ADDENDUM No. 1
Request for Competitive Sealed Proposals (CSP)
20CSP040 Upgrades at Travis Heights Elementary School

December 5, 2019

195012 | Travis Heights Elementary

200025-TRVHT - IMPROVEMENTS TO TRAVIS HEIGHTS ELEM. SCHOOL
2010 Alameda Dr
AUSTIN, TX 78745

SHEET:
ADMIN DESK & DETAILS

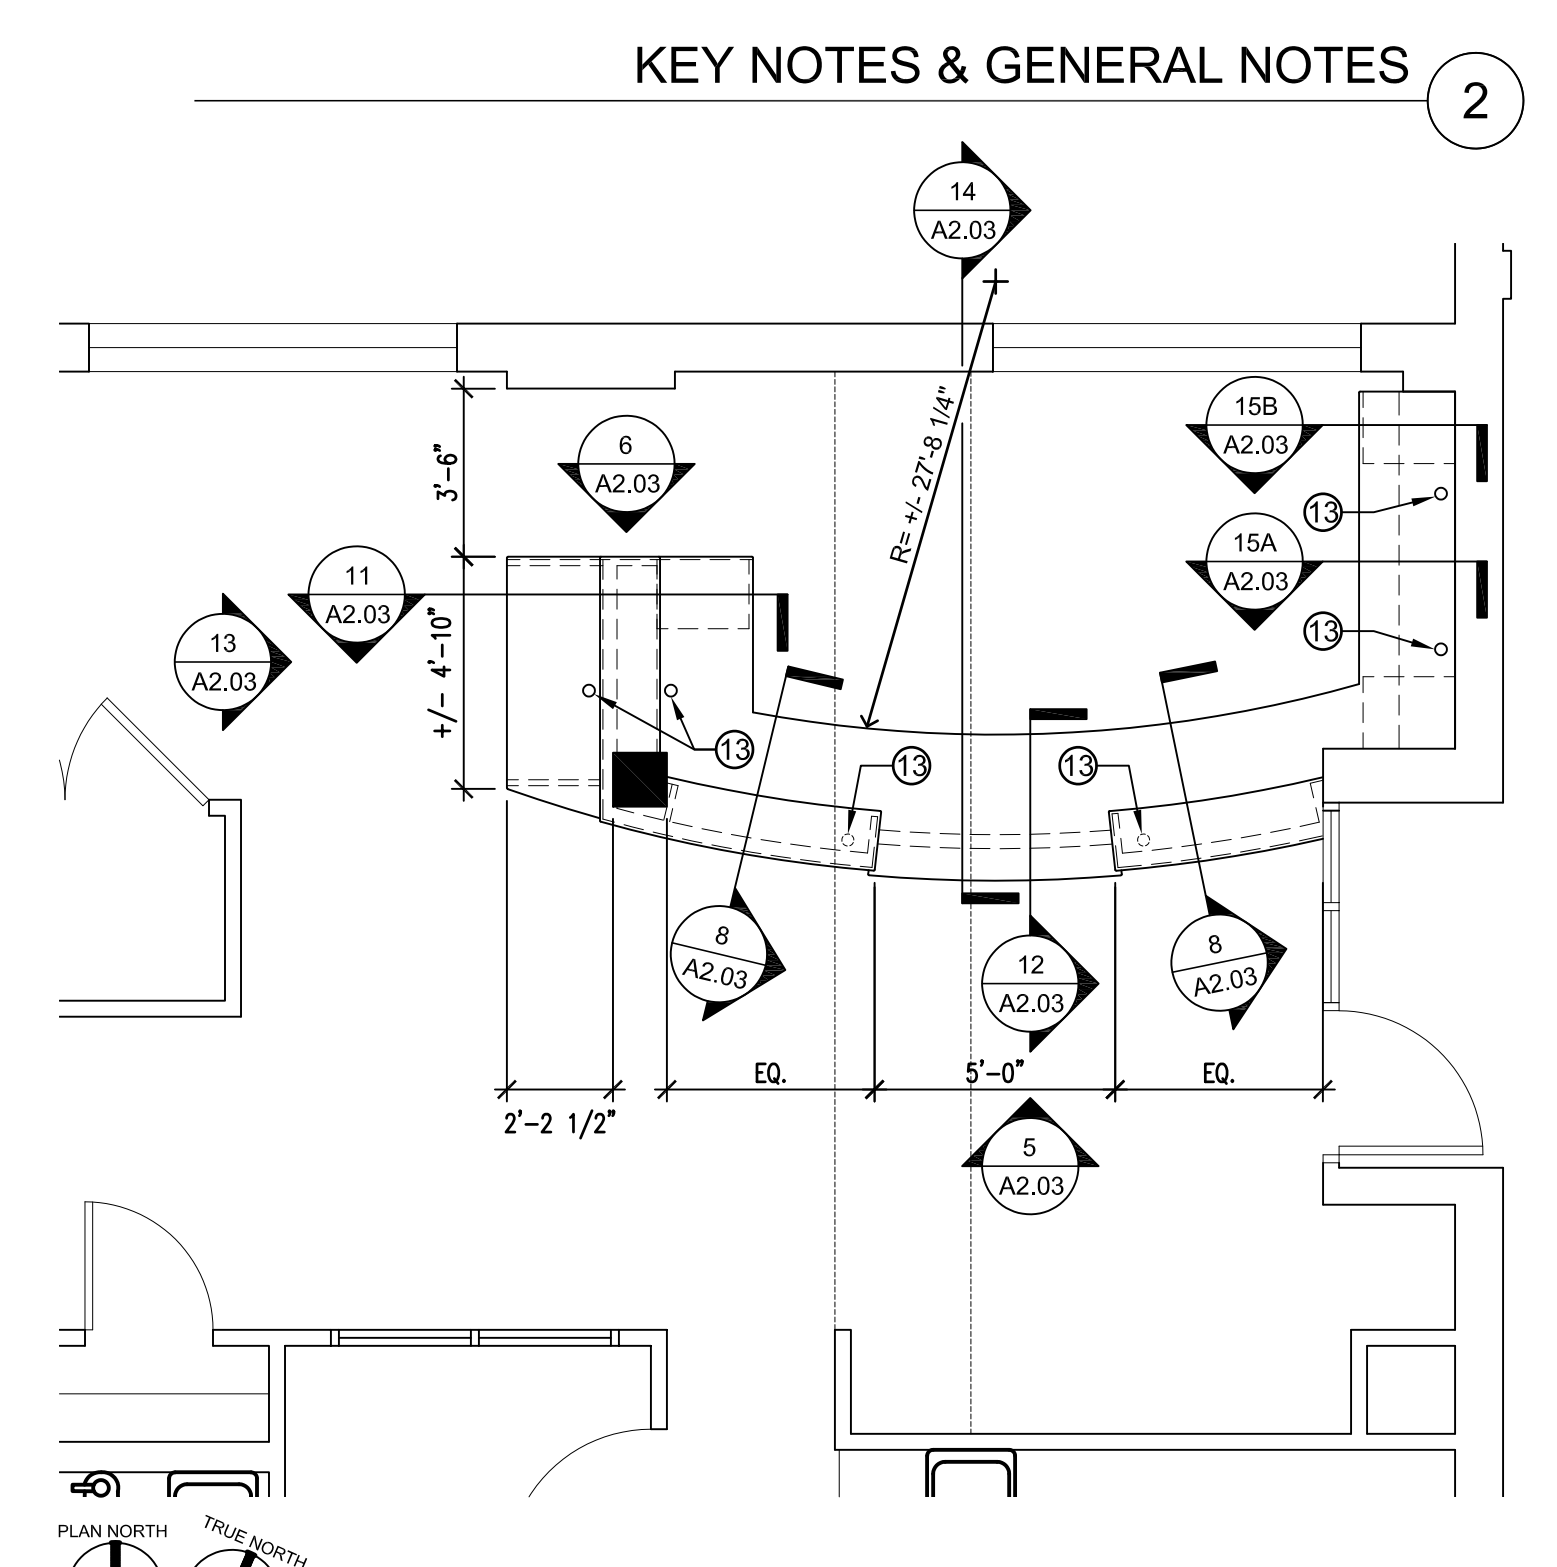
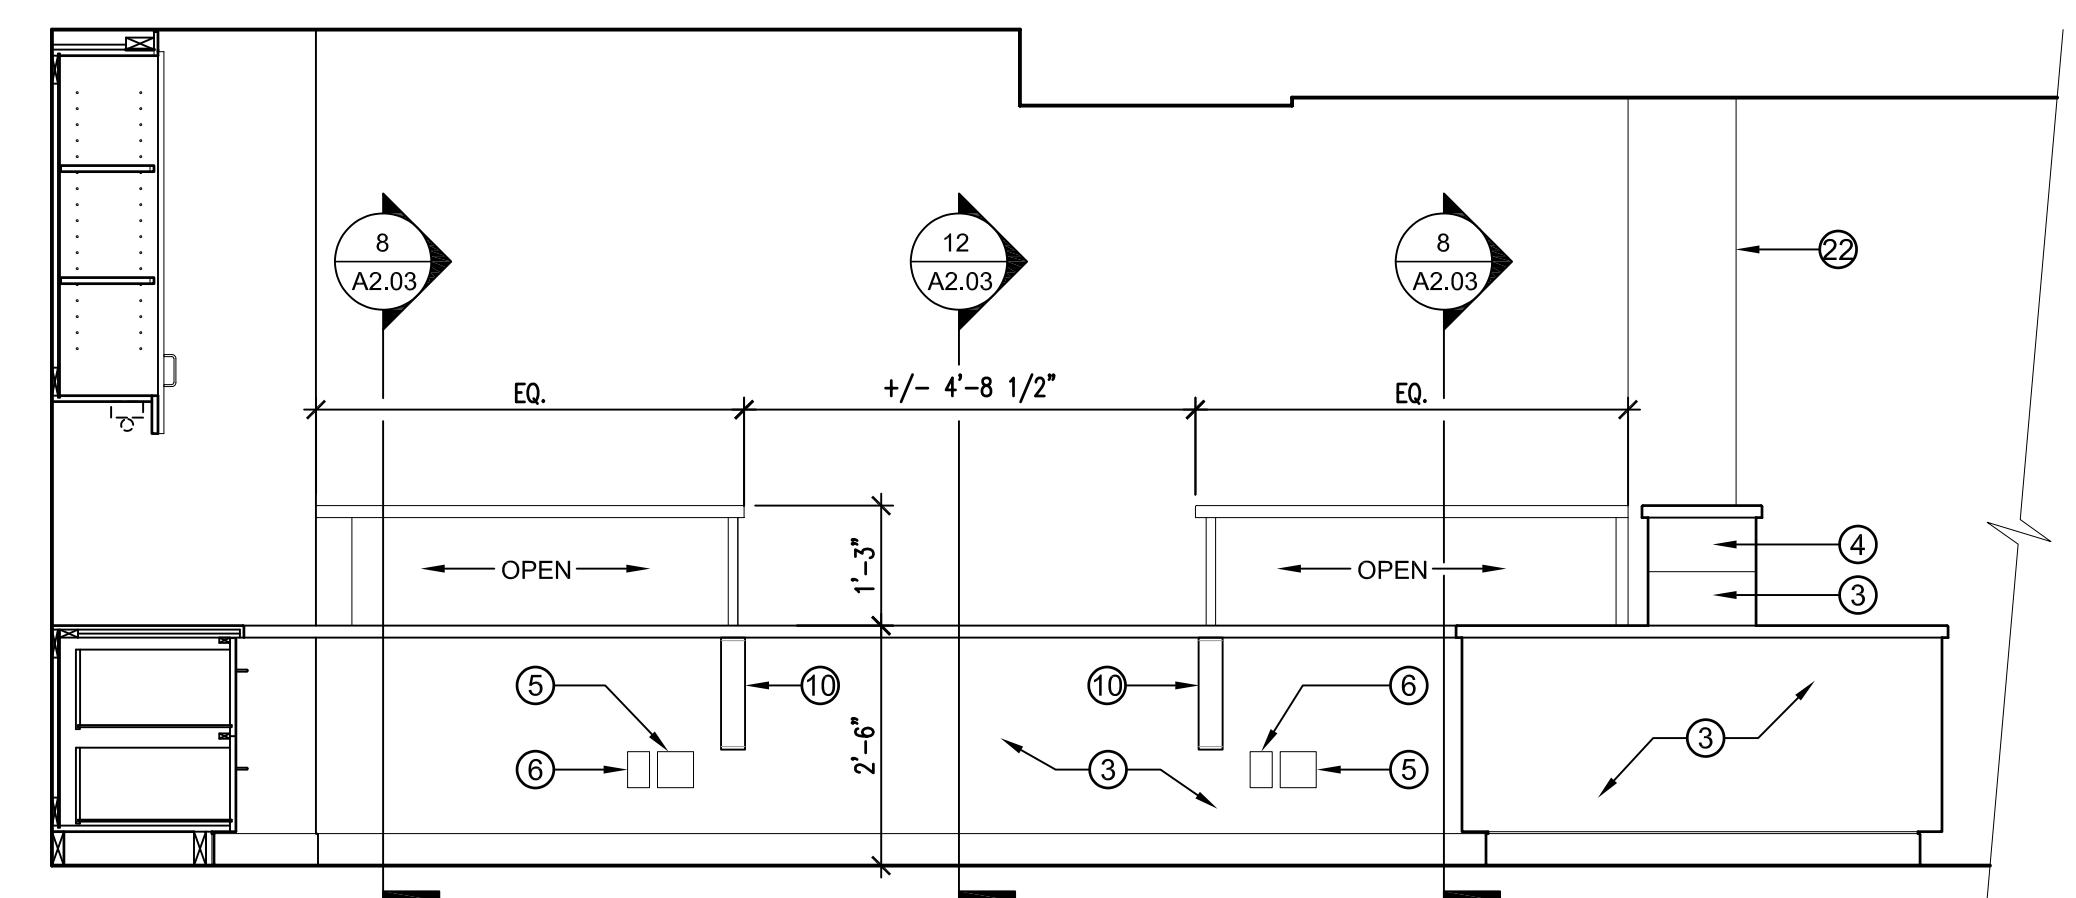
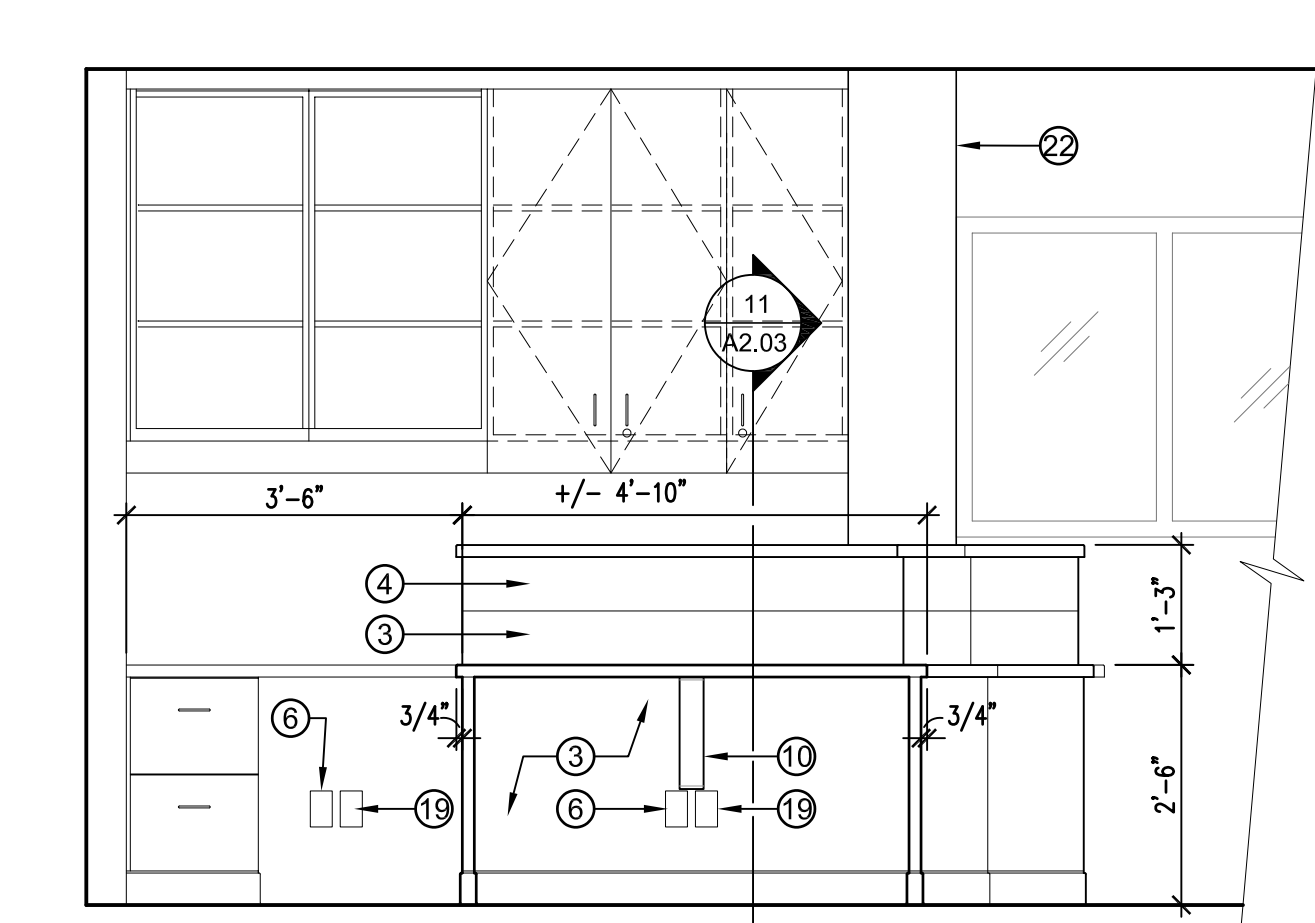
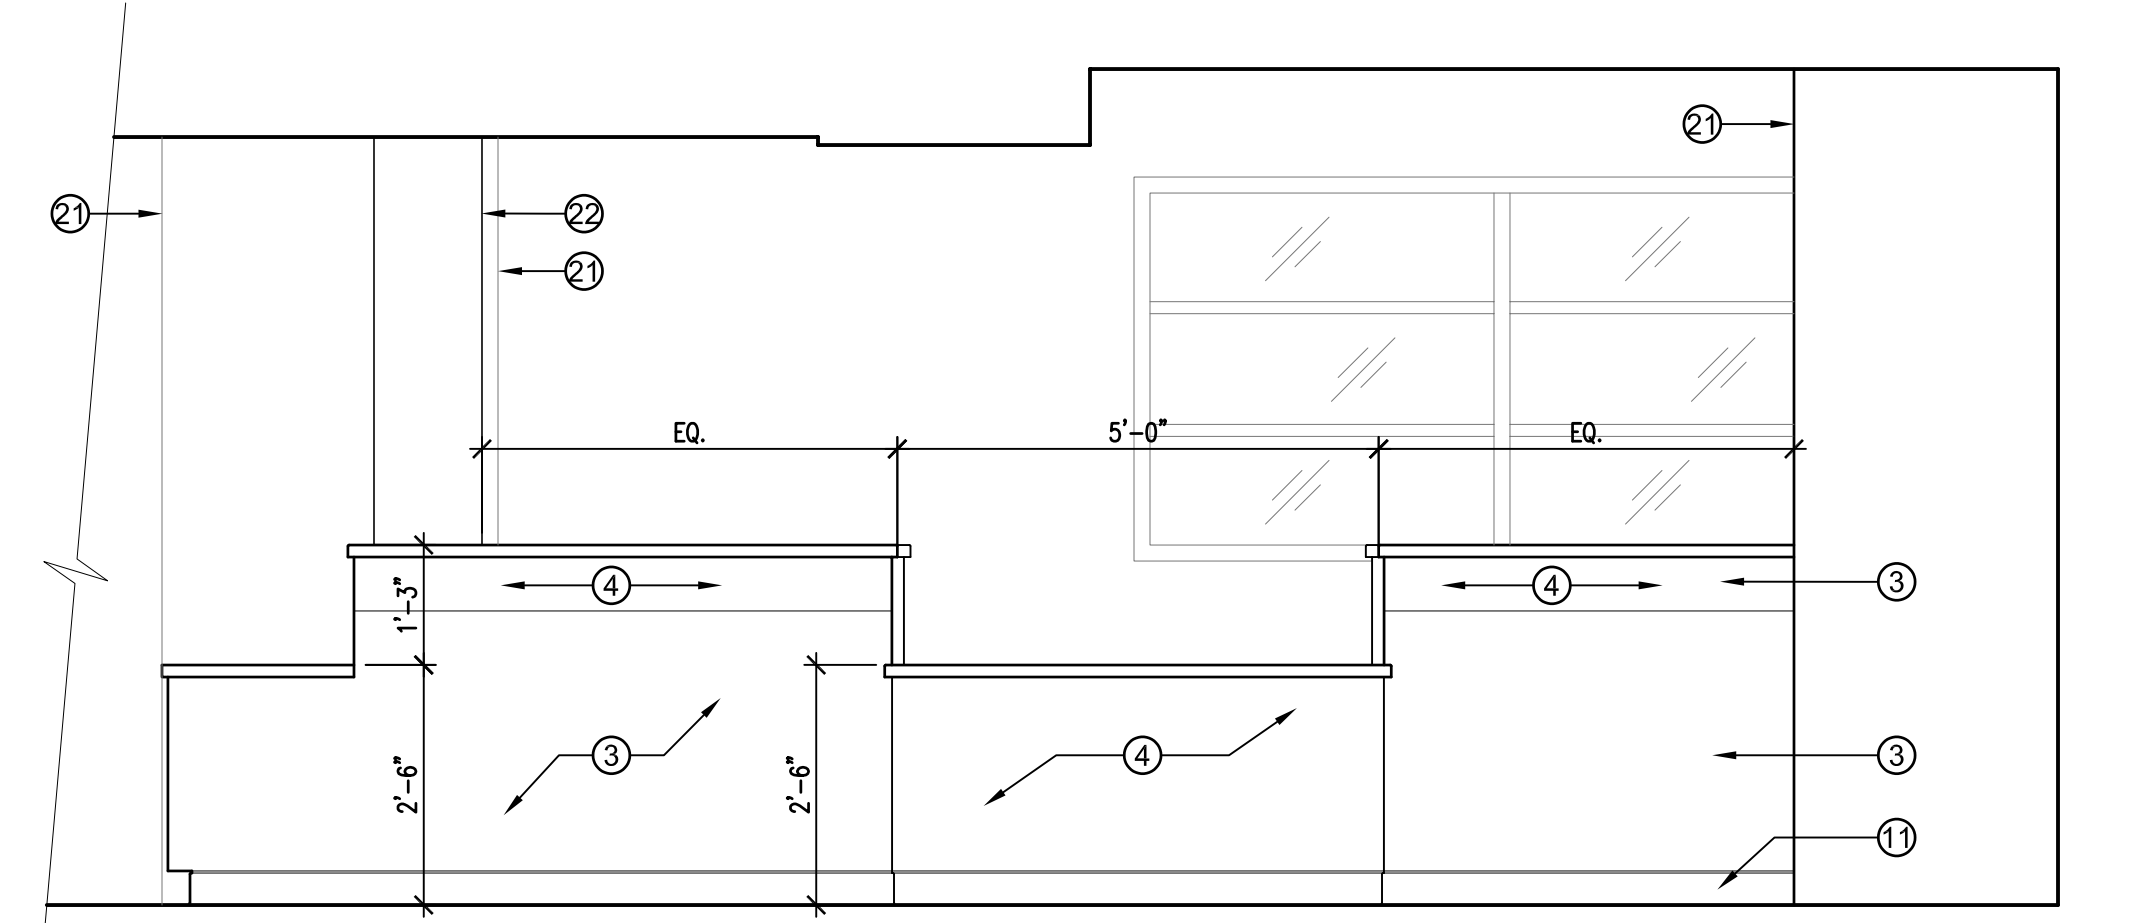
Included in this addendum is the addition of Sheet A2.03 which includes Plans, Elevations and Details for a new Reception Desk in the Admin. office.
